**GE Nuclear Energy**

MFN 03-101  
September 19, 2003

Subject: **Response to Request for Additional Information (RAI) numbers ( 54, 79, 100, 101, 109, 259, 282, 309, 311, 333, and 383) for ESBWR Pre-application Review.**

**Response to NRC RAI numbers (54, 79, 100, 101, 109, 259, 282,  
309, 311, 333, 383)**

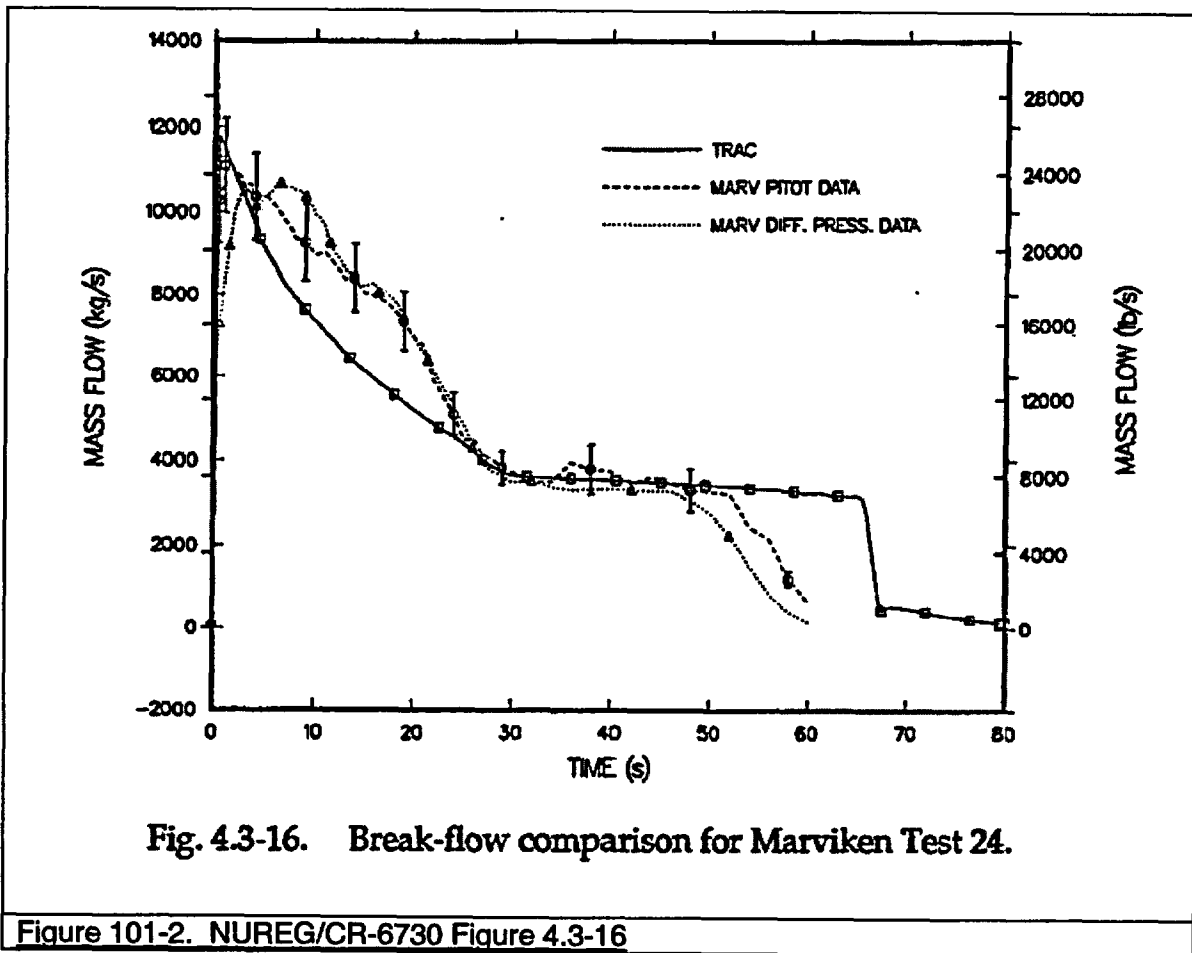
Q100. Section 3.4.1.2 (p. 3-48) - What was the uncertainty of the pressure measurement?

R100 The uncertainty in the pressure measurement for the Marviken critical flow tests is 90 kPa [Reference 100.1].

Figure 333-1 Theoretical Sonic Velocity for HEM of Steam and Water

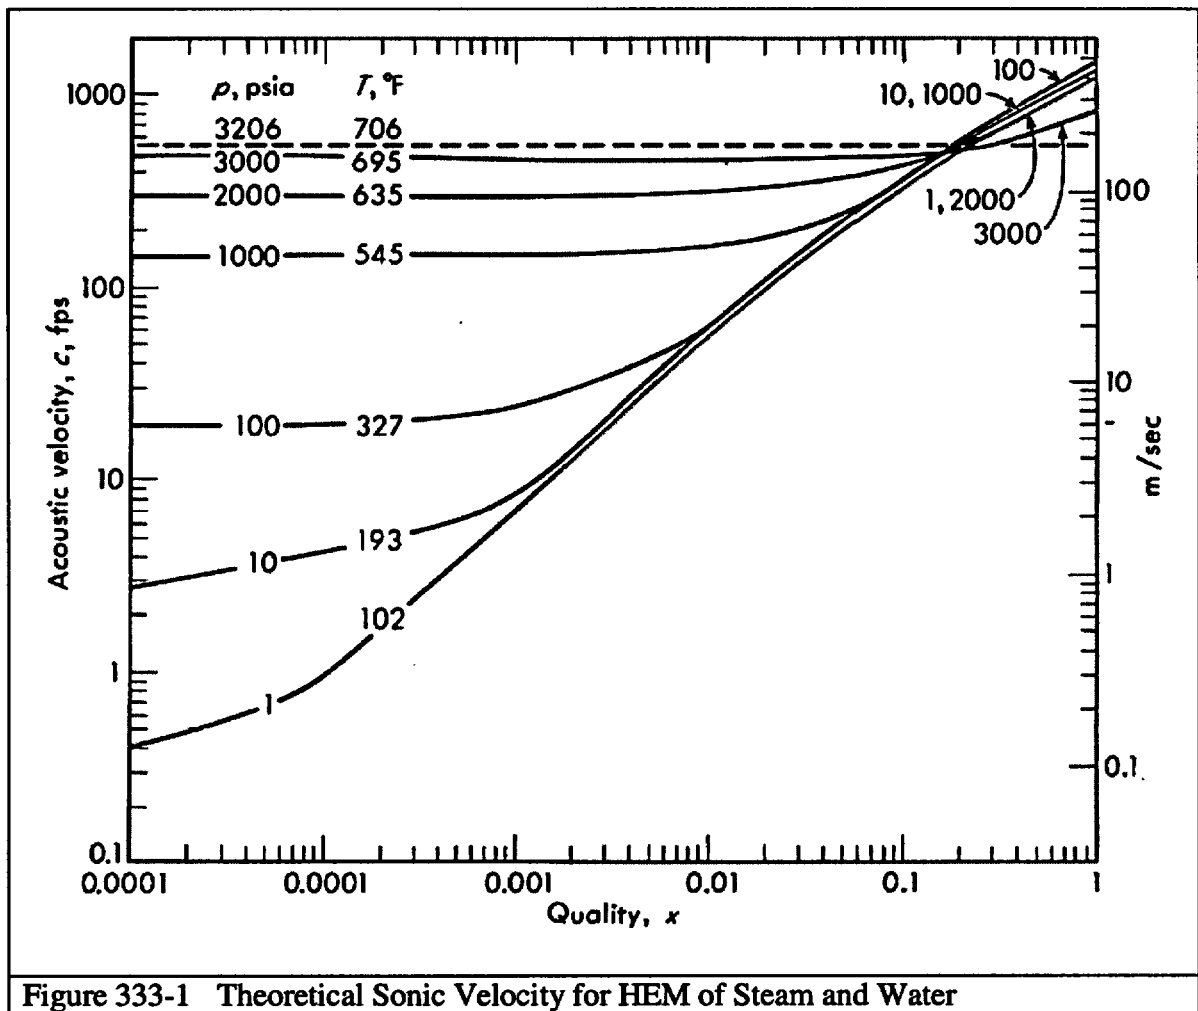
Q333. In order to verify the TRACG critical flow model, we have developed and run a simple test problem. It consists of two break components and a pipe component. Two break components define the pressure boundary conditions (73 bar upstream and atmospheric pressure downstream). A pipe with an orifice at the center was initially set to 73 bar through out its entire length. Then, the downstream break is depressurized to atmospheric pressure. The TRACG code predicts choke condition at the orifice. However, the calculated fluid velocity at the choke point is only about 60 meters per second. Usually, the sound speed is expected to have be on the order of 100 - 300 meters per second. Therefore, the calculated choke flow velocity appears to be lower than the sound speed. Please provide a separate effect test benchmark TRACG deck to assist the staff's further review.

R333. The sonic velocity varies as a function of stagnation pressure and quality at the choke plane. Both have a strong effect on the velocity of sound in homogenous, equilibrium mixtures (HEM) of steam and water. These relationships are shown in Figure 6.11 on page 146 of Graham Wallis's book One-dimensional Two-phase Flow (McGraw Hill, New York, 1969). Wallis attributes the figure to H. B. Karplus (1958). For convenience, it is reproduced here as Figure 333-1. The figure shows that one should expect that for a pressure of 73 bar (1059 psia) that the HEM sonic velocity is approximately 50 m/s for qualities of 0.05 or lower. At the choke plane where the pressure is lower, the sonic velocity is even lower.

The sonic velocity is discontinuous at qualities of 0.0 and 1.0 corresponding to the transitions between single-phase and two-phase flow. This discontinuity in sonic velocity is due to the discontinuity in the specific heat at constant volume ( $C_v$ ) that occurs at these points. The fact that this will lead to a discontinuity in the sonic velocity is evident from equations (D-10), (D-17) and (D-18) in Appendix D of NEDE-32176P (Rev. 2). This discontinuity is the reason that the sonic velocity can be as much as an order of magnitude lower for low-quality steam-water mixtures than it is for single-phase saturated liquid at the same pressure.

Appendix E of NEDE-32176P (Rev. 2) contains the derivation of the HEM sonic velocity that is used in TRACG. The crux of the problem is to define the compressibility at constant entropy. The simplified form with no noncondensable gas is presented in Eq. (E-40). Free and Spore have obtained the same result (see References 6.3-1 and 6.3-2 cited in NEDE-32176P, Rev. 2). The conclusion is that the fluid velocity of approximately 60 m/s calculated by TRACG at the choke point is a reasonable value.
